SERVICE BULLETIN

SUBJECT: NIGHT RIDER and FREEDOM MEMORY CHIP COMBINATIONS

You may have noticed a new look on two of the printed circuit boards used in POWER PLAY. The basic change is to single sided printed circuit boards on the Display Driver Module and the Solenoid Driver/Voltage Regulator Module. The new boards also carry a new part number:

THE FOLLOWING IS A LIST OF CORRECTIONS TO BE MADE ON ALL EIGHT BALL SCHEMATICS:

See attached display pictures: AS2518-15 and AS2518-21.

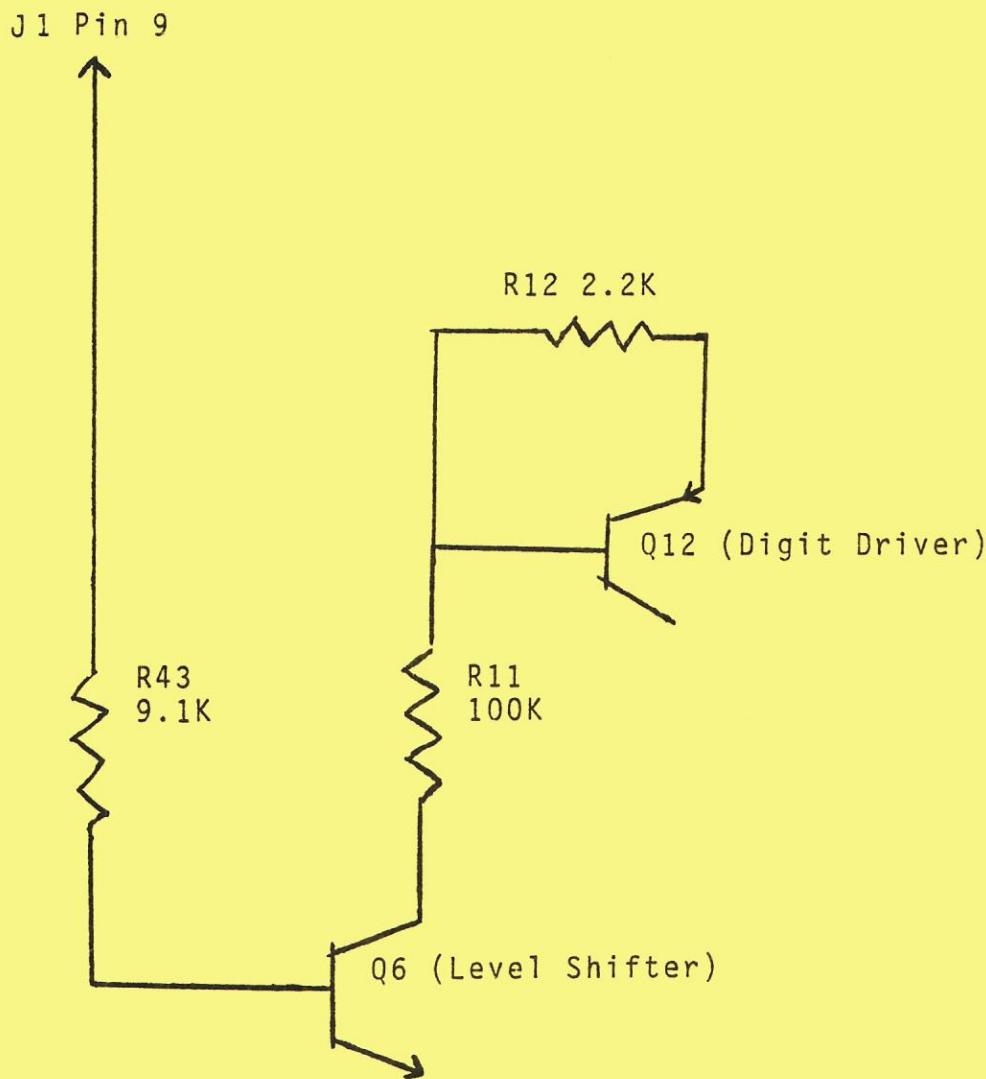
Display Driver	Was AS2518-15	Now is AS2518-21
Solenoid Driver/Voltage Regulator	Was AS2518-16	Now is AS2518-21

There were two significant changes on the Display Board and they are:

1. The Test Points (TP1 and TP2) were moved. TP1 was moved to a more accessible point to work with. TP2 (190VDC) was moved to the front of the board -- closer to the display -- so that it is not as accessible to be hit by mistake.

100,000 PT DIGIT EXTRACT

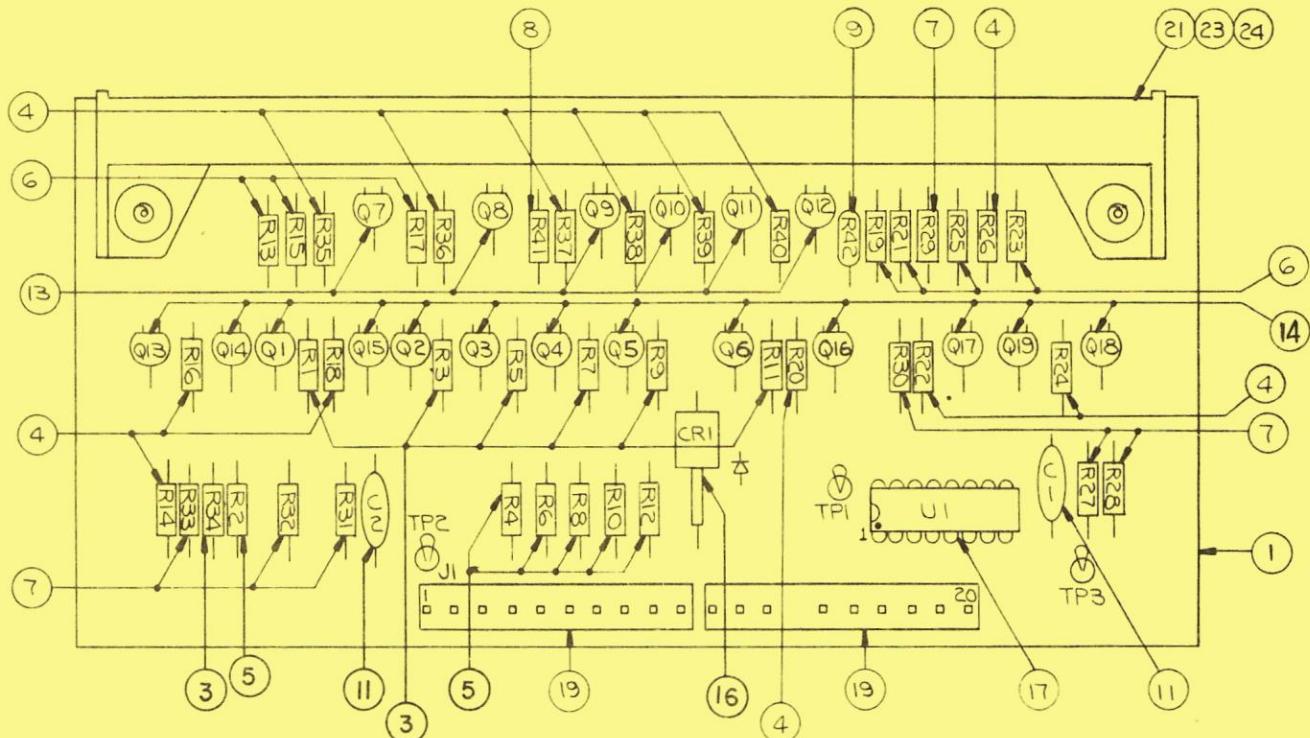
2. The Level Shifter Base resistors were renumbered. They were: R2, 4, 6, 8, 10 and 12. They have been renumbered, respectively, R48, 47, 46, 45, 44 and 43.

Attached is an extract of a portion of the 100,000 pt digital schematic representation. The base resistor of the Level Shifter (Q6), as you can see, is now R43. On the schematics for AS2518-15, it would be R12.

It should also be noted that there needs to be a note added to page 45, Symptom II of the F.O. 560 "BALLY Electronic Pinball Games Repair Procedure." Symptom II, Cause A, Procedure reads "Use AID 1 probe junction of base resistor (R2, 4, 6, 8, 10 or 12, as appropriate) and connector.

It should read ". . . (R2, 4, 6, 8, 10 or 12 on AS2518-15; or R48, 47, 46, 45, 44 or 43 on AS2518-21, as appropriate). . ."

AS-2518-21 DISPLAY DRIVER MODULE

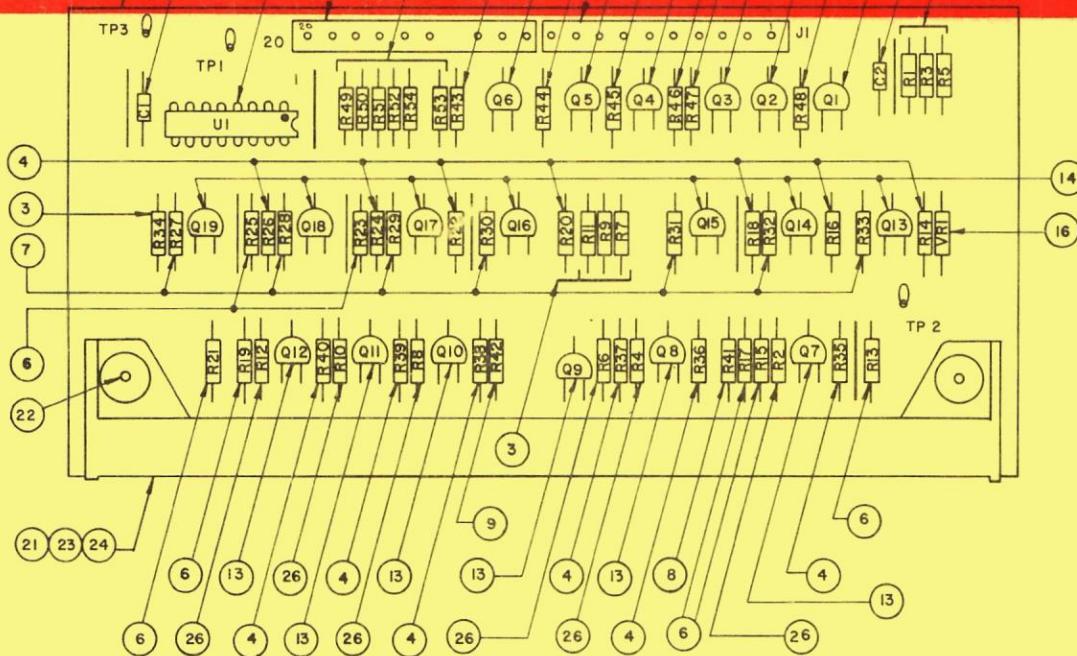
NOTE: INTERCHANGEABLE WITH AS-2518-15

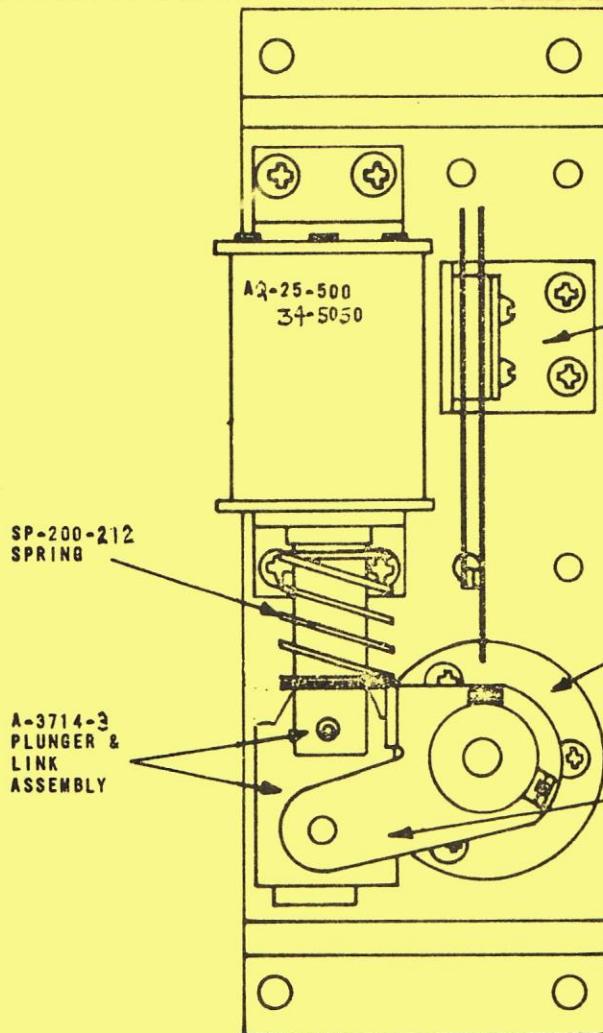
- C. Also attached is a typical playfield wiring diagram for an electronic flipper game, with the addition of a one Amp.slow blow fuse in the solenoid circuit.

This fuse is in series with the 43 volt line to all playfield solenoids except the flippers.

A-3714-3
PLUNGER & LINK ASSEM.

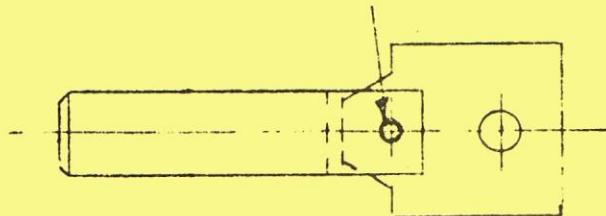
- A. Attached is an assembly drawing of a BALLY electronic flipper. It shows two new assemblies: the SP-200-212 spring and the A3714-3 plunger and link assembly.

These are designed to REPLACE the SP200-211 spring and the A3714-2 plunger and link assembly.

The addition of these components is the recommended method for correcting flipper hang-up on some electronic games.

FIGURE 1 CUT AND HOLE LOCATIONS

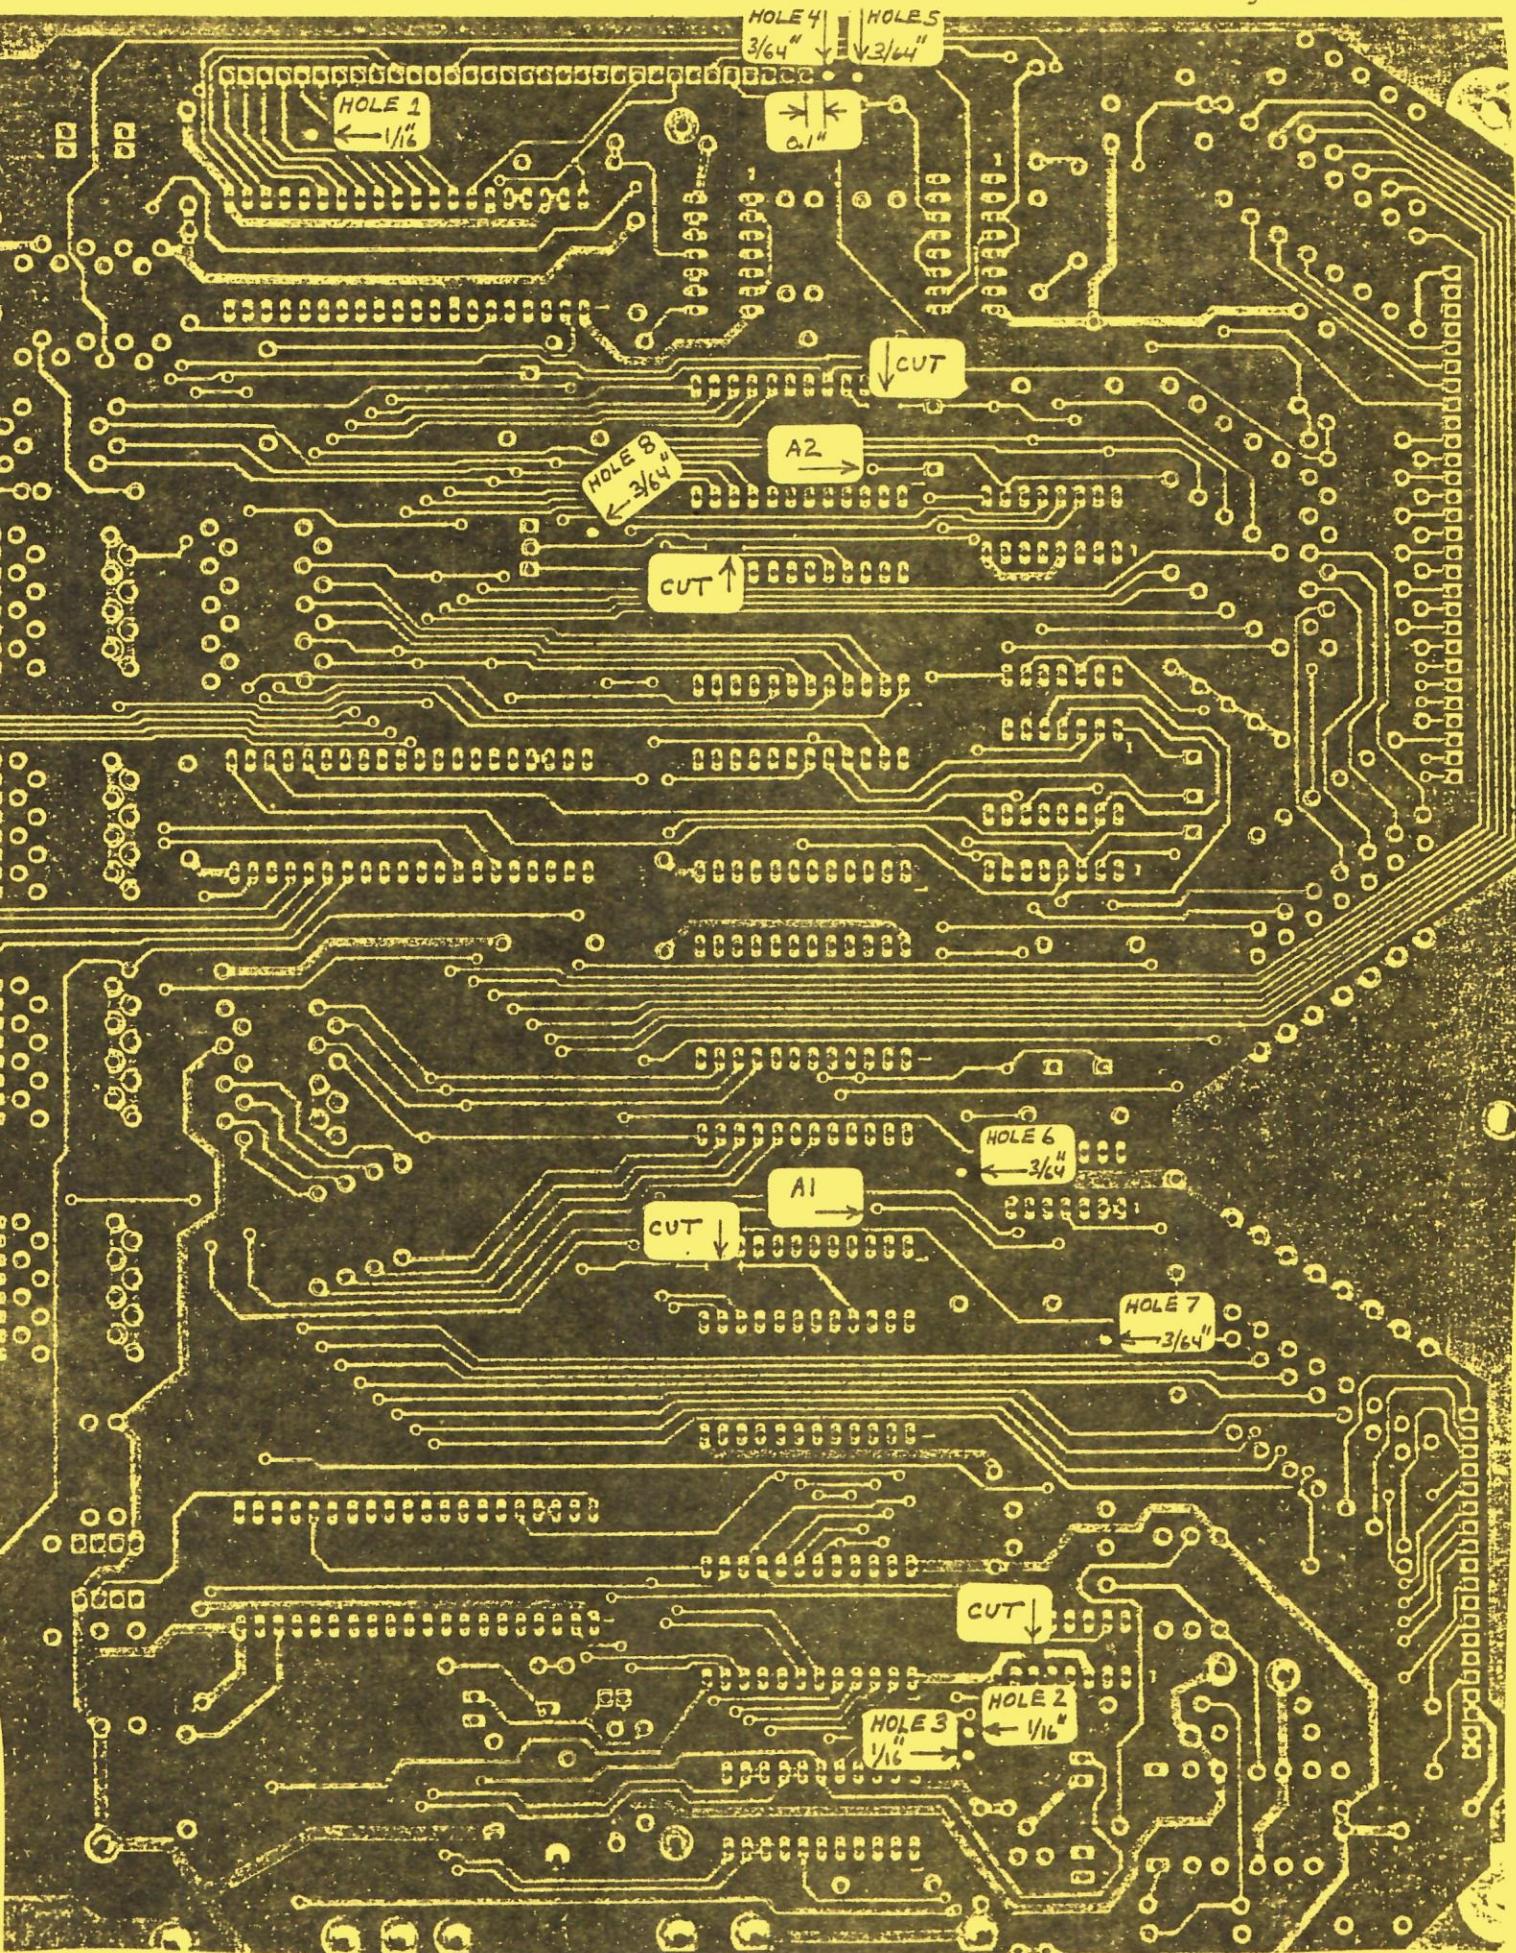
3. Using a razor blade or razor blade knife, cut foil on back of module in the four places shown in Fig. 1.
4. On component side, cut trace running from U5-21 toward U4. Note that this is the fifth small foil away from the large foil that runs near pins 1 and 24 of U5. Cut trace approximately 1/8" from pin 21.

5. Carefully locate and drill three 1/16" holes as shown in Fig. 1. Hold board up to light to locate holes in non-foil areas of board. Hole edge must not touch foil leads and must not break any foil leads. Repeat this procedure for the five 3/64" holes shown in Fig. 1. Note that hole 4 is located on 0.1" centers from pin 32 of J5.

FIGURE 2

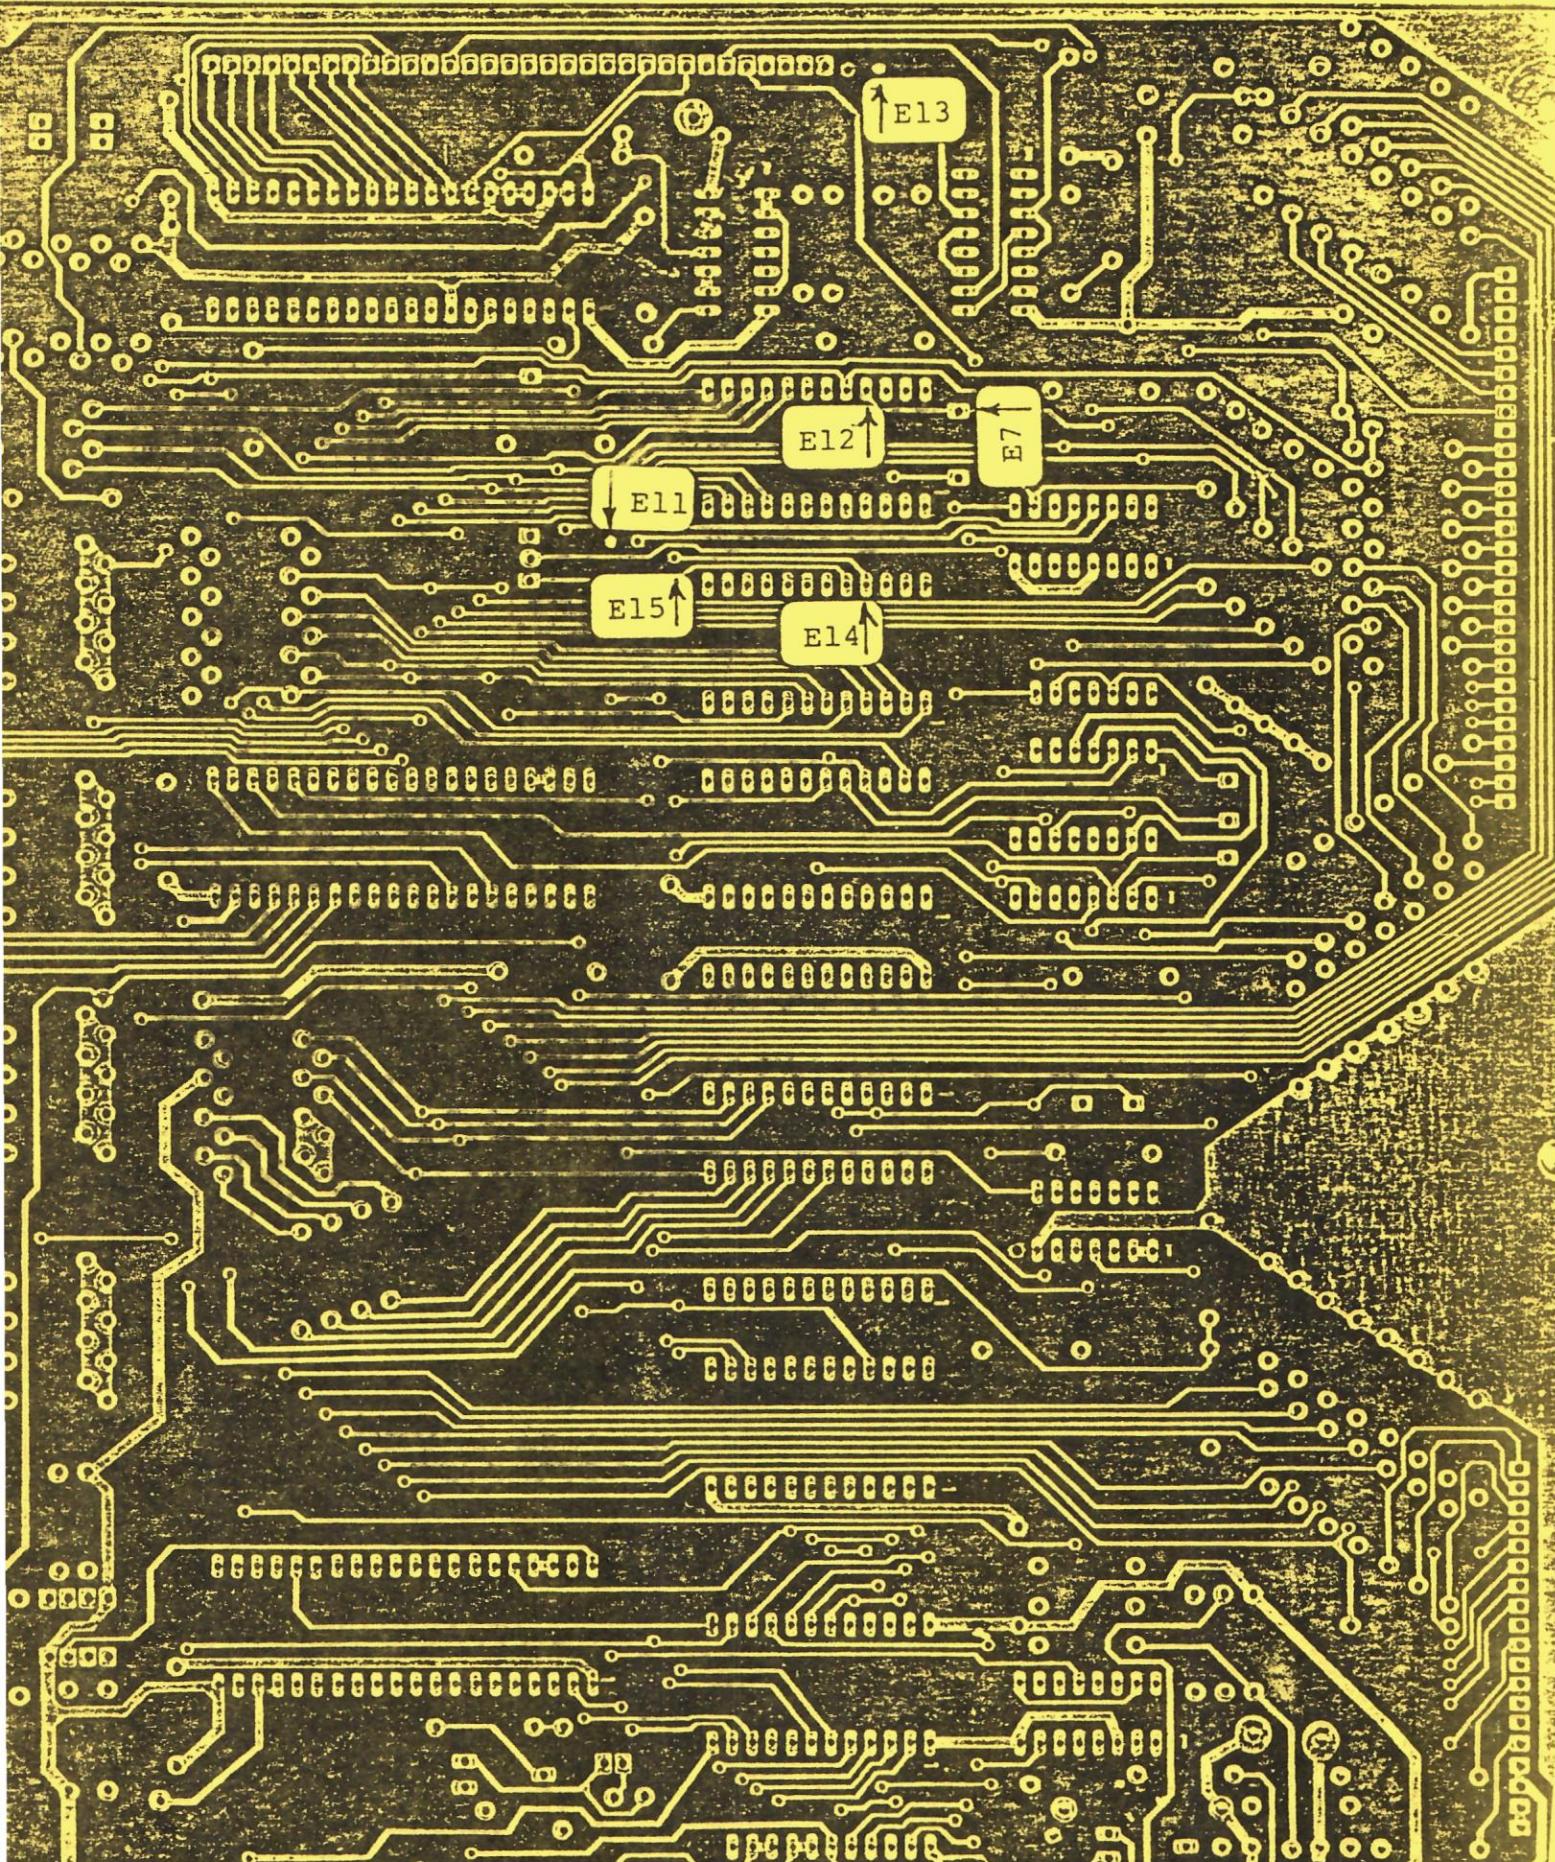
10. Place the six "E" tie point labels on the backside of the MPU, locating them in the EXACT location shown in Fig. 2. Place the label "AS-2518-17 MODIFIED PER F.O. 597", on the topside between R39-R42 and the board edge.
